UNITED STATES PATENT AND TRADEMARK OFFICE

APPLICATION NO.	FILING DATE	FIRST NAMED INVENTOR	ATTORNEY DOCKET NO.	CONFIRMATION NO.
10/801,828	03/15/2004	Chien-Ting Lai		3134

DETAILED ACTION

Replacement Sheet

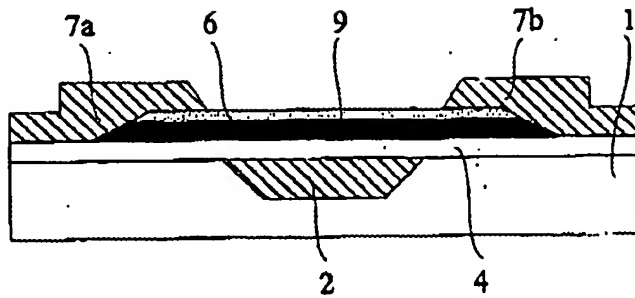
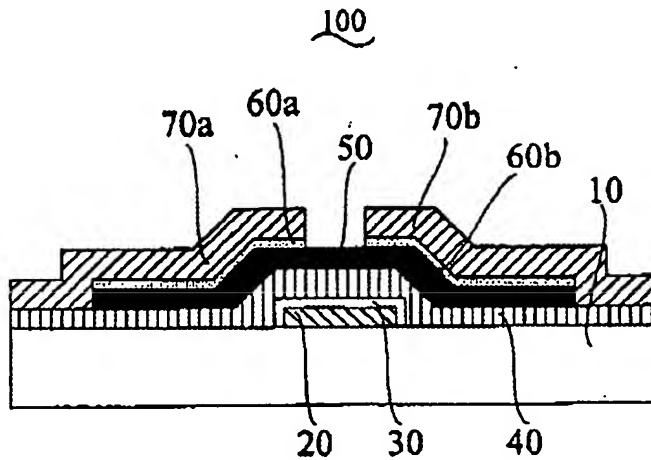
1. The corrected drawing filed on 02/28/05 is approved.

Approved
TO
04/25/05
